APPLICATION NO.	FILING DATE	FIRST NAMED INVENTOR	ATTORNEY DOCKET NO.	CONFIRMATION NO.
09/532,775	03/22/2000	Takashi Kano	000352	8757

# Office Action Summary

## DETAILED ACTION

F I G. 1

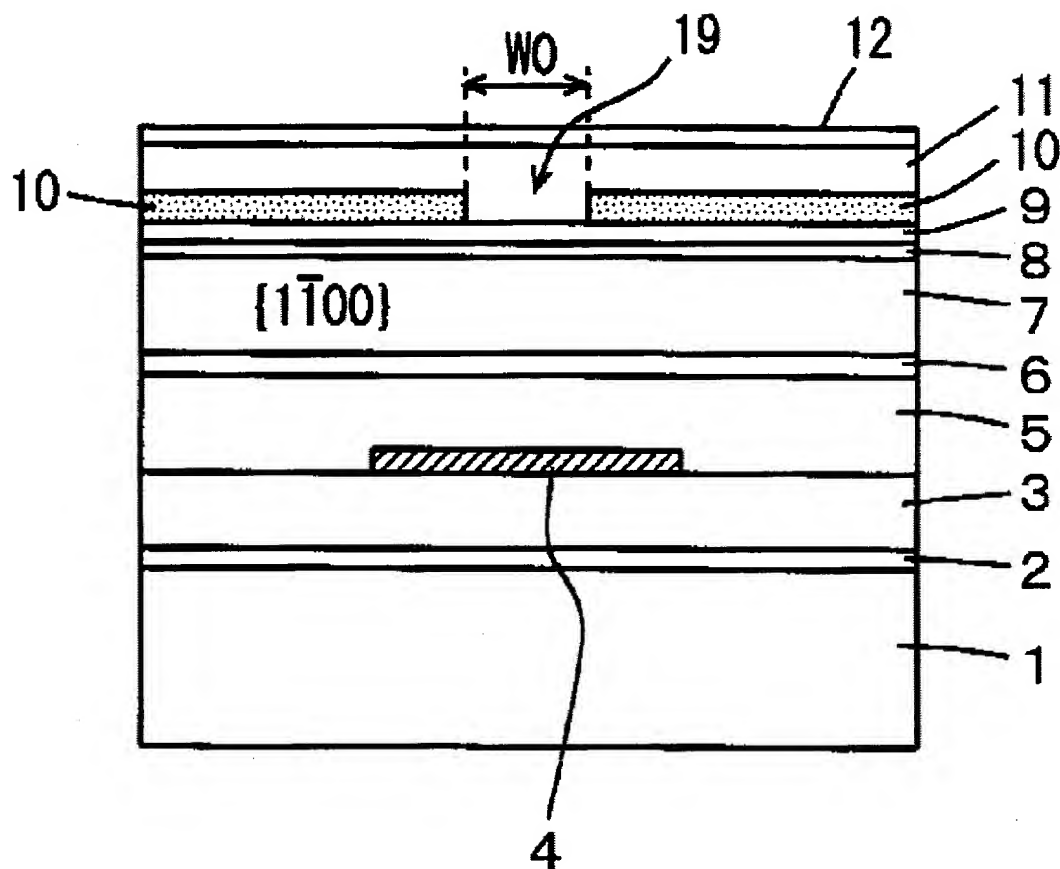
With respect to claim 1, Hayashi et al discloses a method of forming nitride based semiconductor layer comprises a sapphire substrate (1), an AlGa<sub>N</sub> buffer layer (2), undoped Ga<sub>N</sub> layer (3), SiO<sub>2</sub> film (4), n-Ga<sub>N</sub> layer (5), n-InAlGa<sub>N</sub> crack preventing (6), n-AlGa<sub>N</sub> gladding (7), multi quantum well active layer (8), p-AlGa<sub>N</sub> cladding layer (9), current blocking layer (10), p-AlGa<sub>N</sub> cladding layer (11), p-Ga<sub>N</sub> contact layer (12), current injection region (19), and striped region having a width WO, note cols. 3-12, see fig 1.

With respect to claim 3, Hayashi et al shows the nitride based semiconductor layer includes a first cladding (7n), an active layer (8), and a second conductivity type first cladding layer (11), see fig. 1.

With respect to claims 11 and 15-16, Hayashi et al discussed about the active layer includes at least one quantum well layer containing indium, gallium and nitrogen (8), note cols. 3-12, see fig 1-6.
